Major Site Plan Application

RE: Major Site Plan Application - Resubmittal
H2OBX RV Resort
Currituck County, North Carolina

POST DEVELOPED DRAINAGE AREA MAP
H2OBX RV & WATERPARK RESORT
H2OBX, LLC
CURRITUCK COUNTY
POPLAR BRANCH TOWNSHIP
NORTH CAROLINA

SITE & LANDSCAPING PLAN
H2OBX RV & WATERPARK RESORT
H2OBX, LLC
NORTH CAROLINA
CURRITUCK COUNTY
POPLAR BRANCH TOWNSHIP

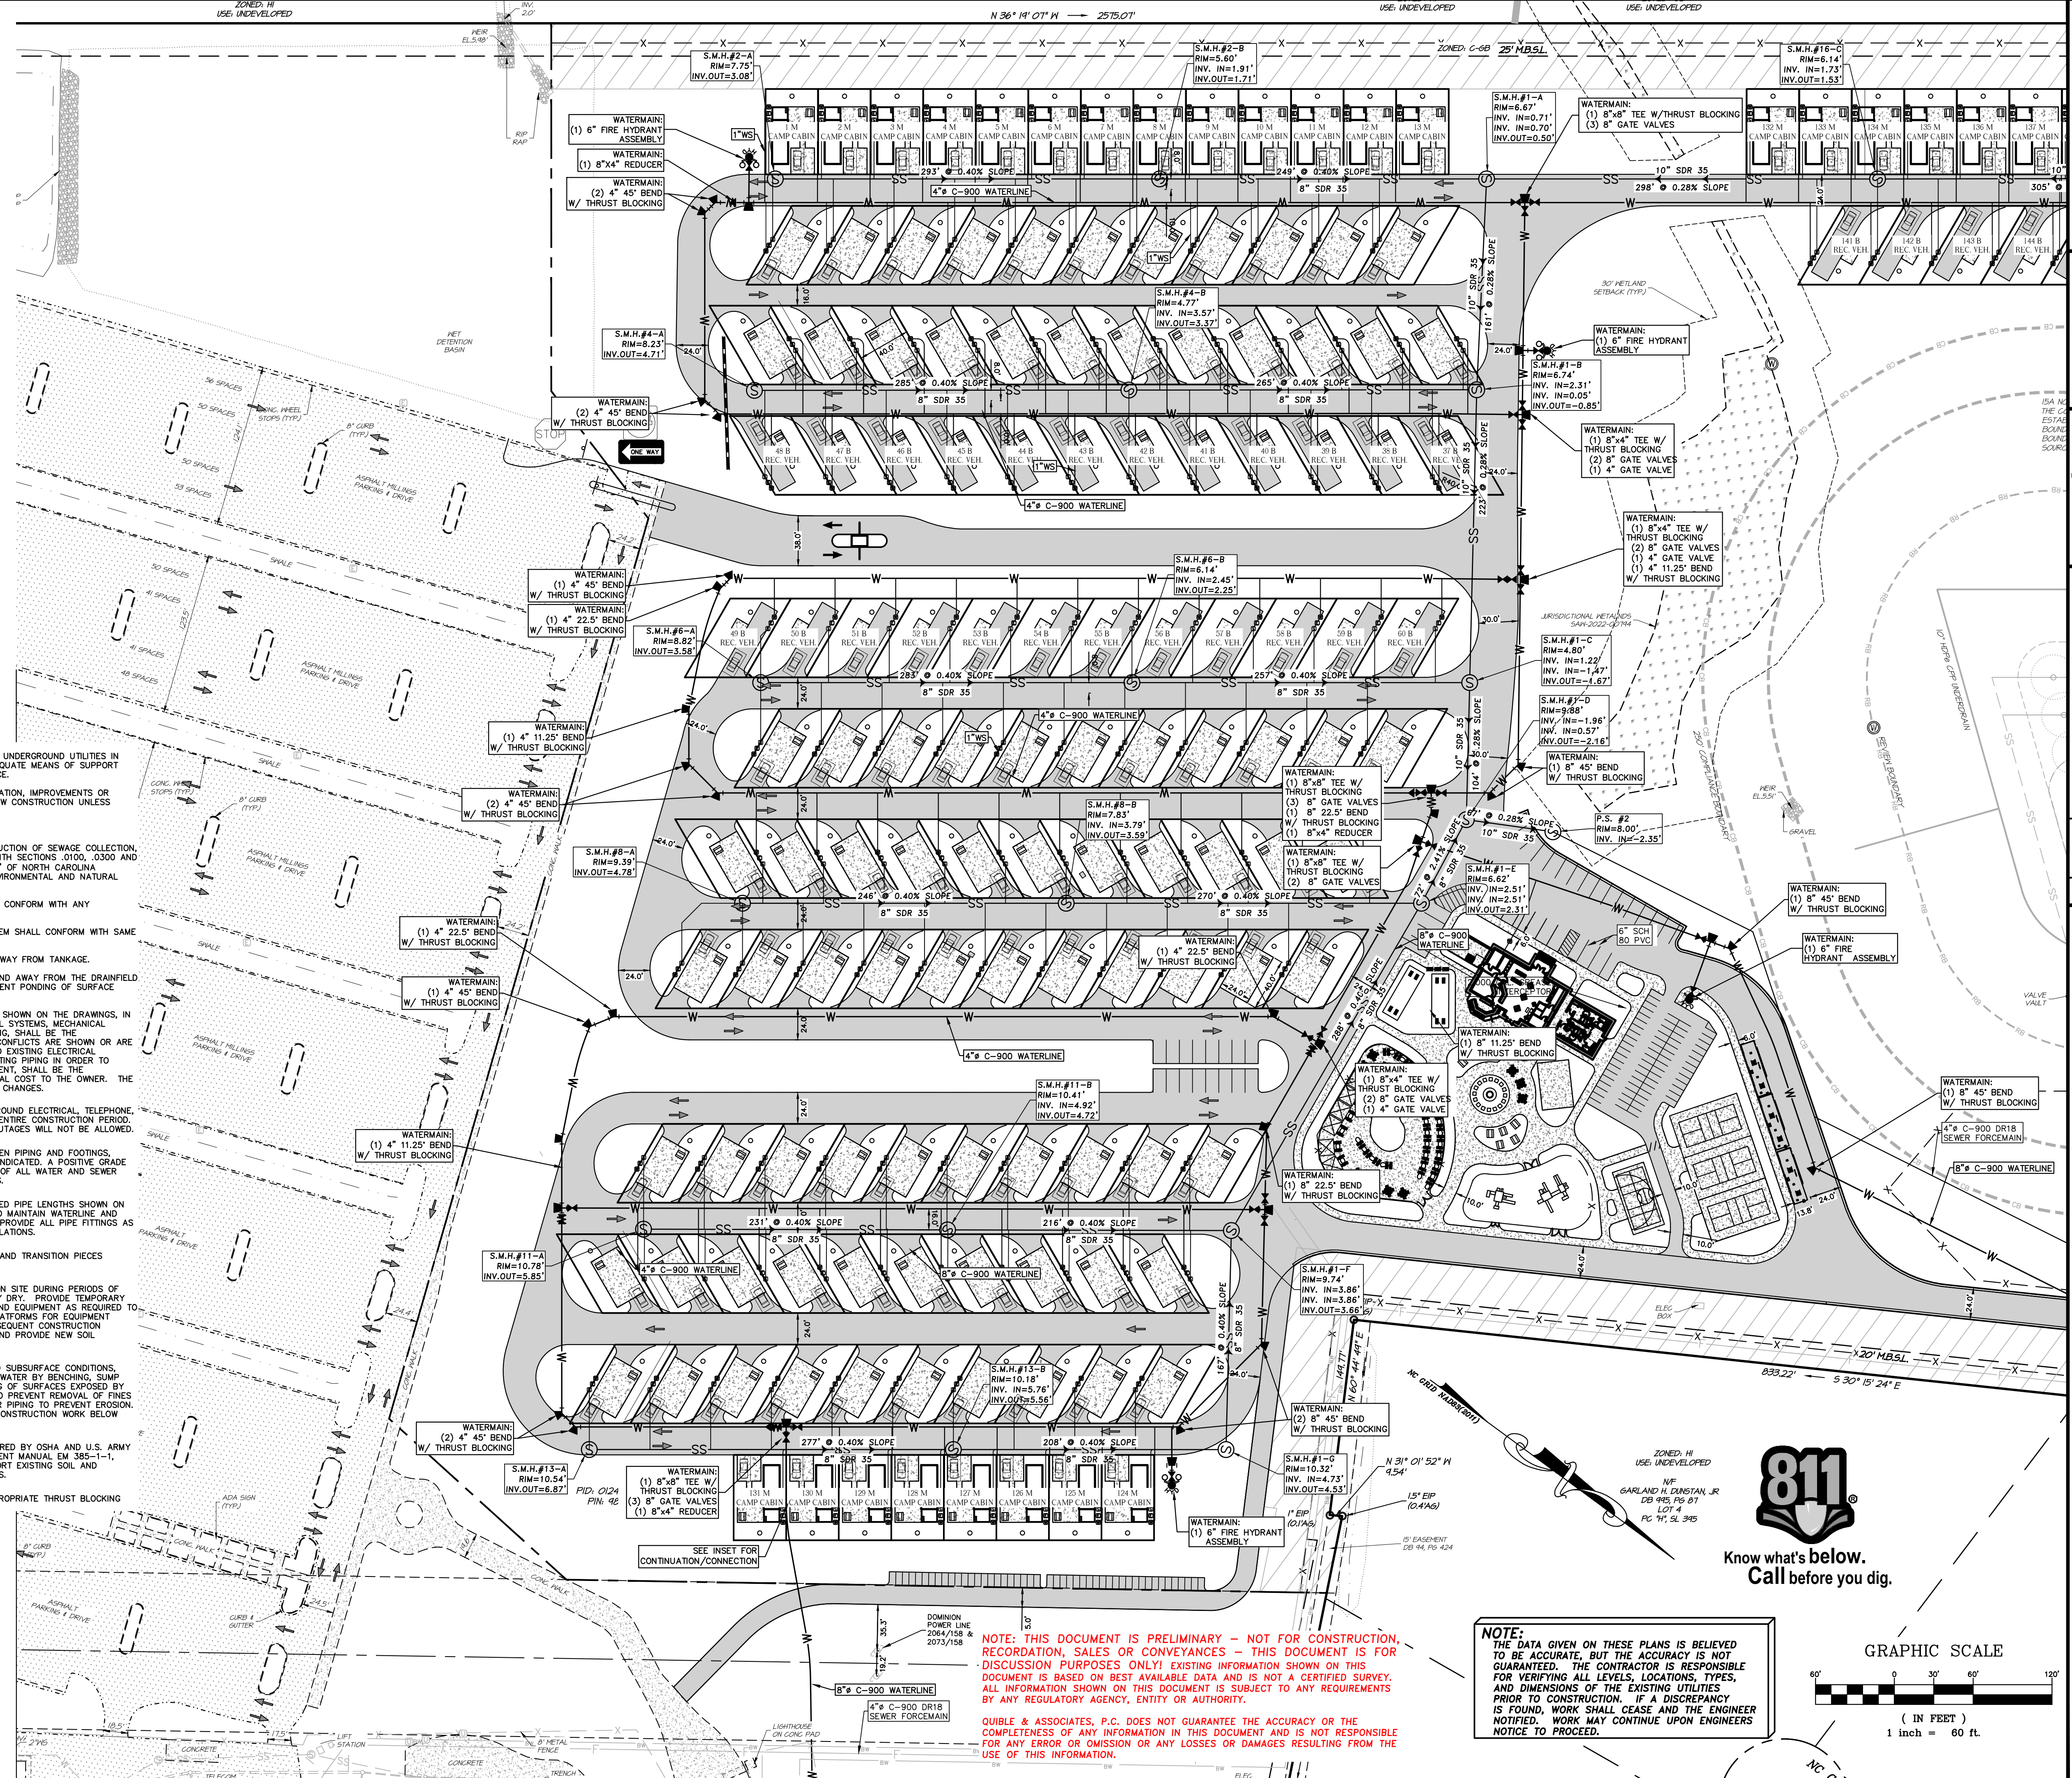
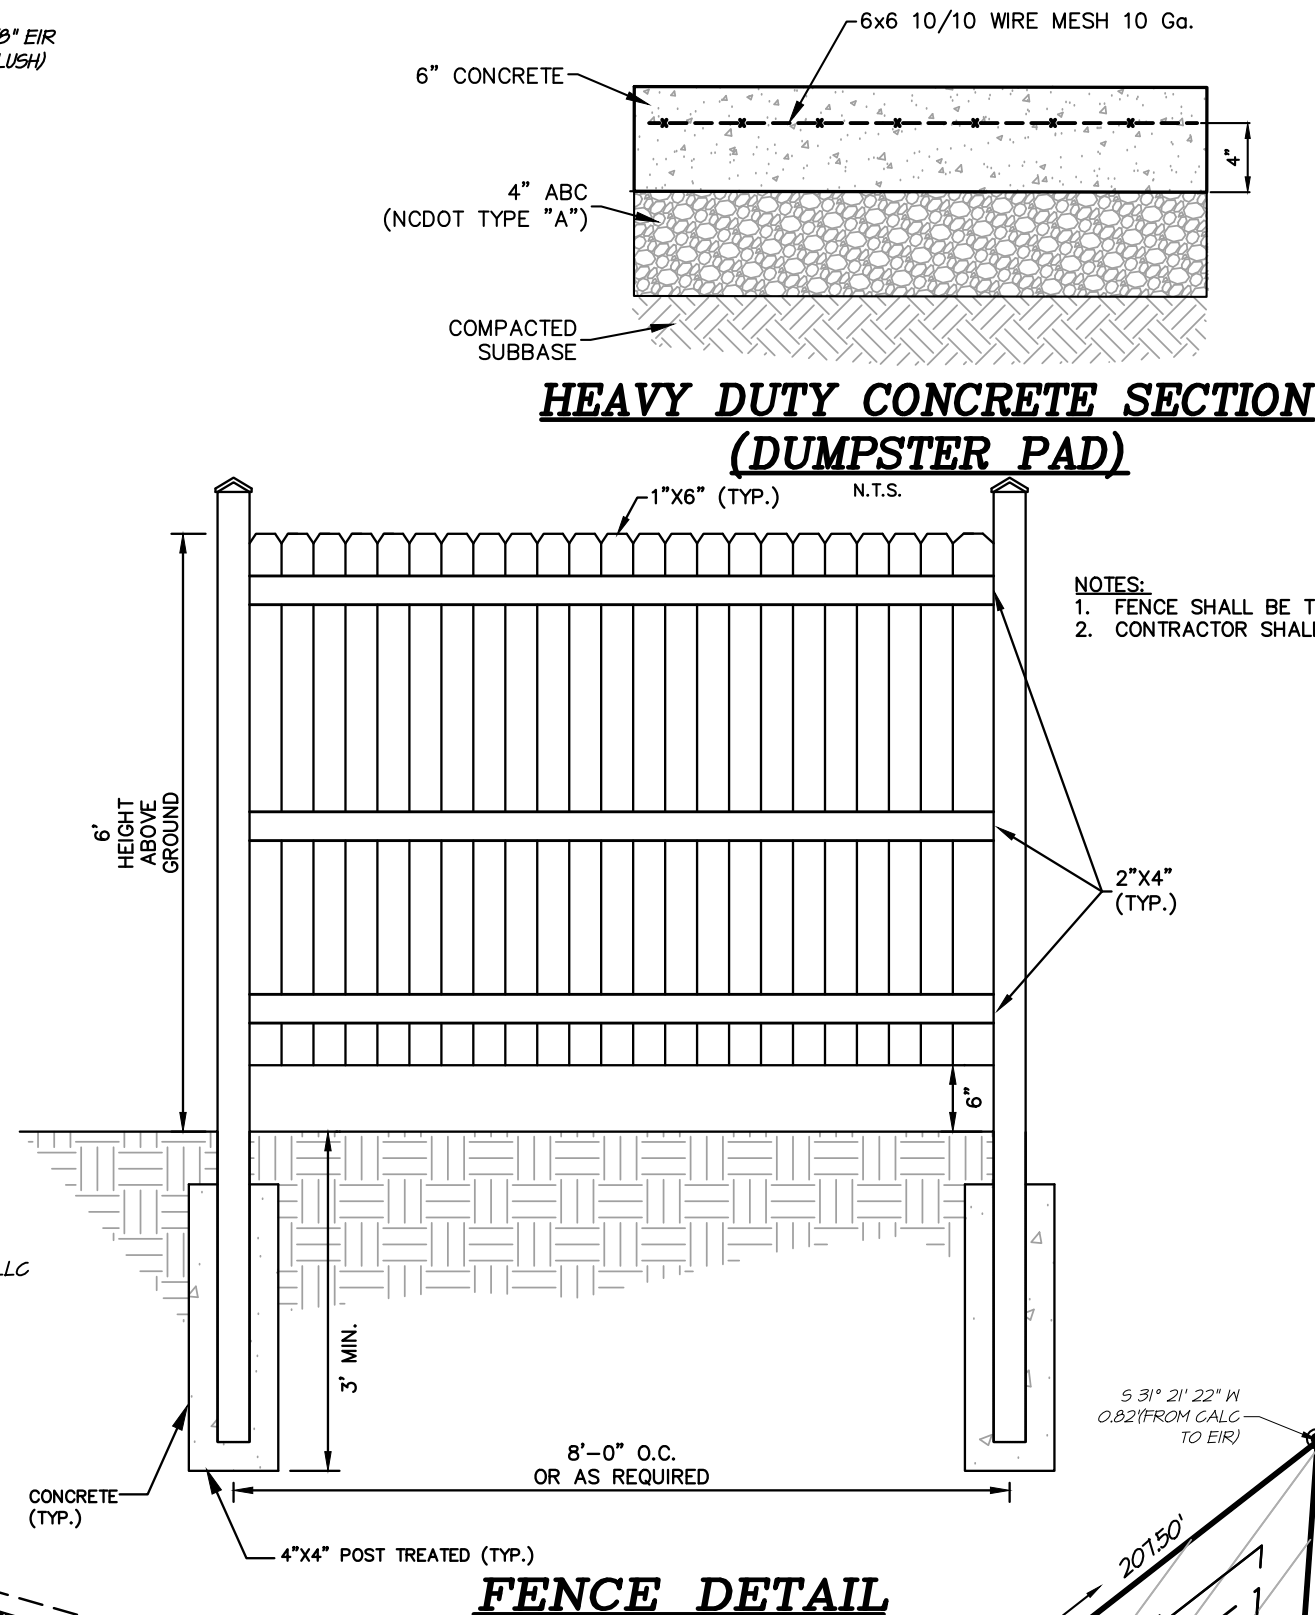
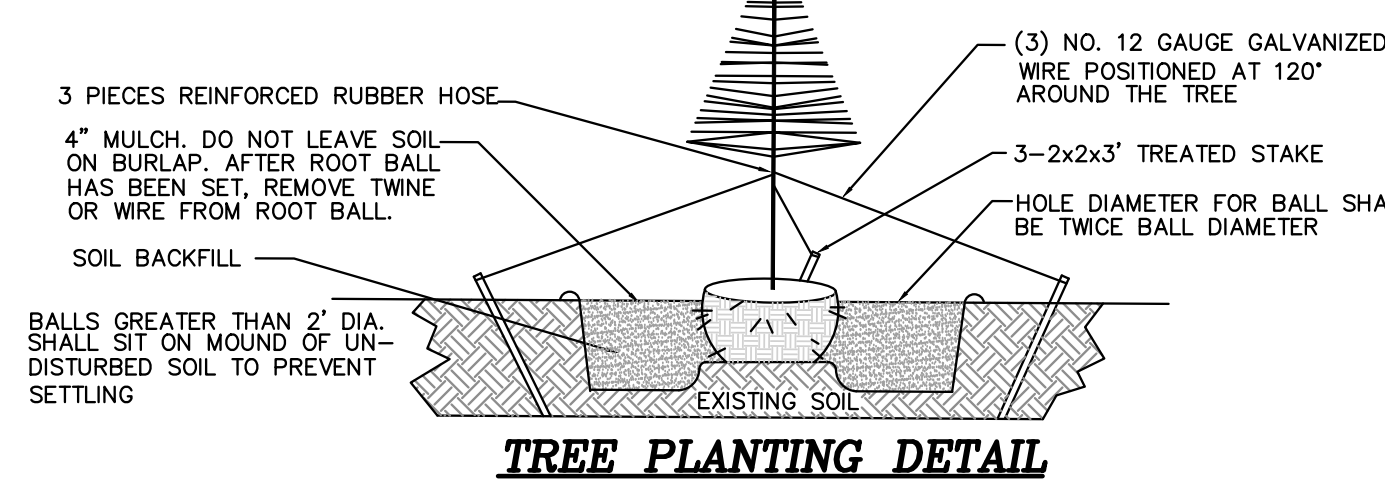
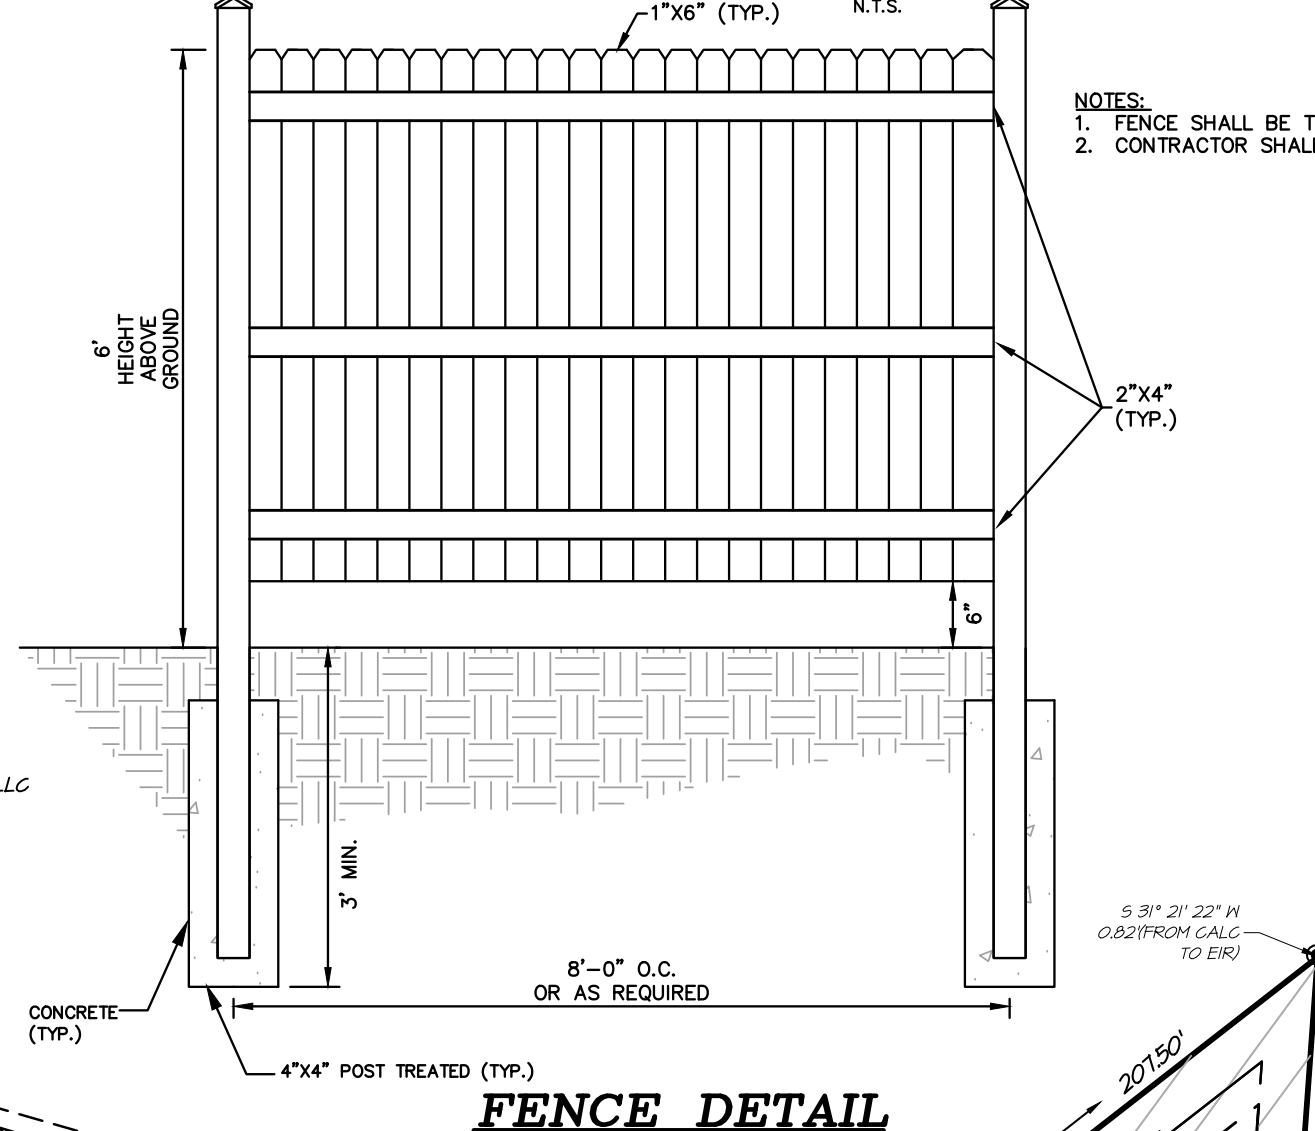
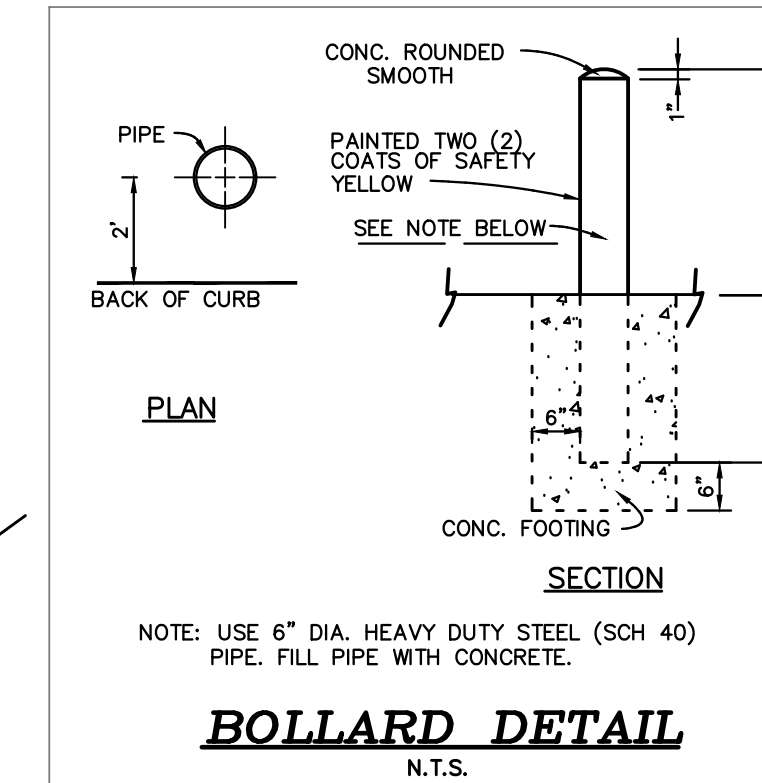
4. "Private Access-Not for campground use" signage shall be placed where Ballast Rock Road terminates. *Acknowledged. Please see sheet 5 of the plan set requiring sign to state, "Private Access-Not for campground use."*

18. Please provide a detailed fence and wall plan. *Acknowledged. Please see the fence layout and detail on sheet 5.*
19. Are any storage areas proposed for rvs, boats, watercraft, and associated trailers? If so, please show on plan per UDO Section 4.2.4.J.(3)(g)(ii) *Acknowledged. There are no proposed storage areas for RV's, boats, watercraft and associated trailers.*

14. Consider installation of bike racks where appropriate. *Acknowledged. Bike racks have been shown on Sheet 4 adjacent to the amenity area.*
15. Dumpster pad must be on 6" thick concrete. Include detail on plan. *Acknowledged. Please see the concrete dumpster pad on sheet 5.*
